Product Change Notification – 2021/02

Product Line:	Stacking Jacks	Part No:	NSJ*H*
---------------	-----------------------	----------	---------------

Engineering Change Request:	2020-0360 2020-0361 2020-0362 2020-0363 2020-0364 2020-0365	Date:	04 Feb. 2021
-----------------------------	--	-------	--------------

Engineering Change Notice

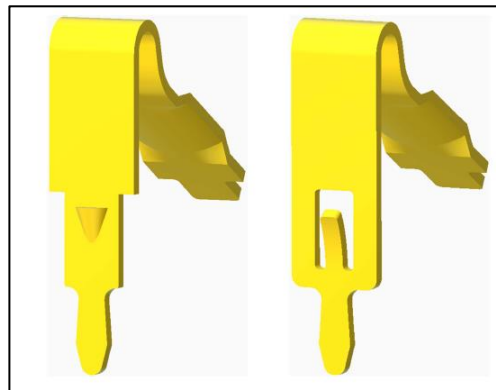
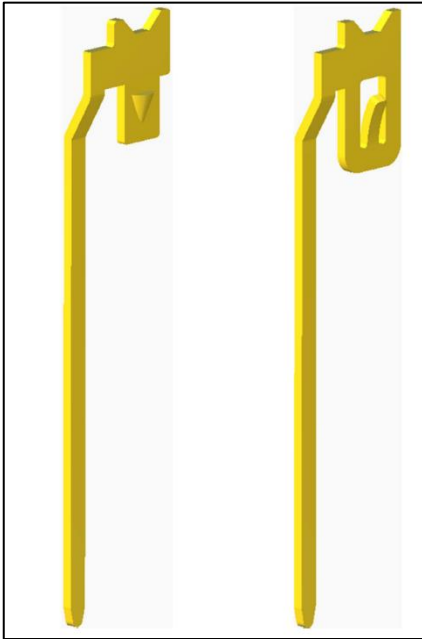
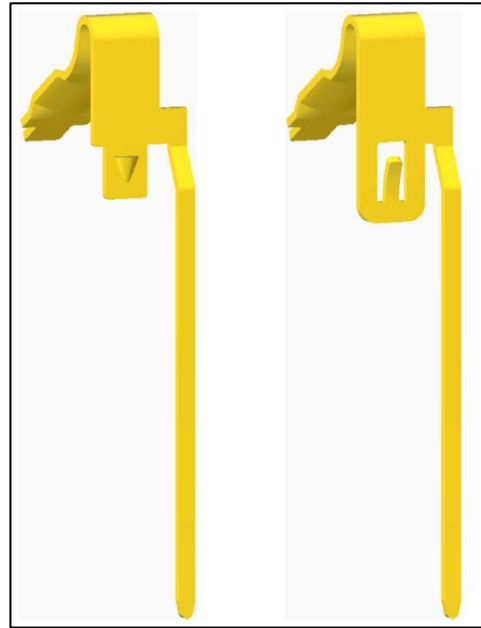
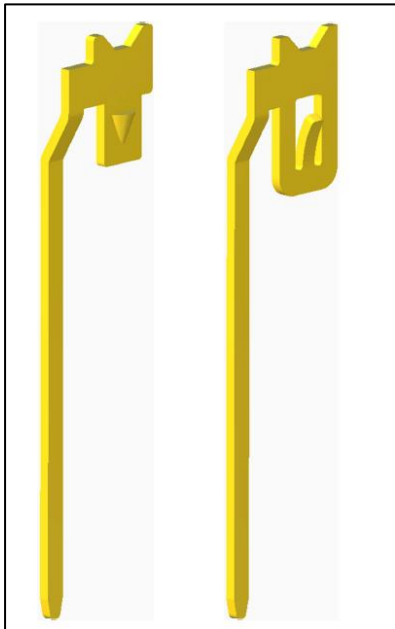
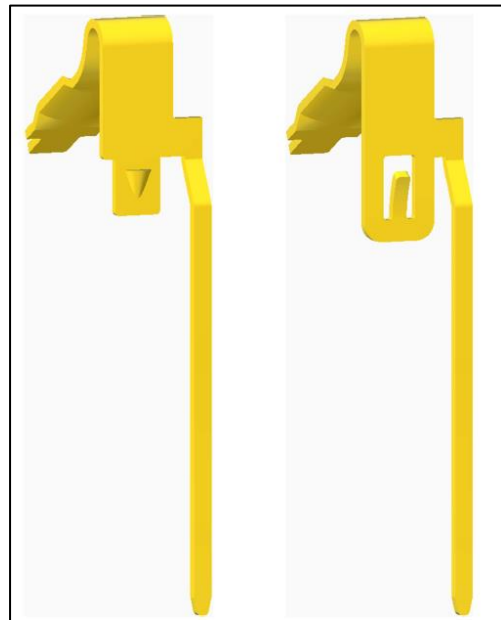
Comments:	Material upgrade UL94 HB to UL94 V-0
-----------	--------------------------------------

Due to the new IEC 62368-1 standard the Neutrik Stacking Jacks have been modified. To ensure the compliance according to this new standard, the material has been changed from UL94 HB to UL94 V-0 classification. Because of slight different material properties also the contacts were changed to ensure robustness and durability.
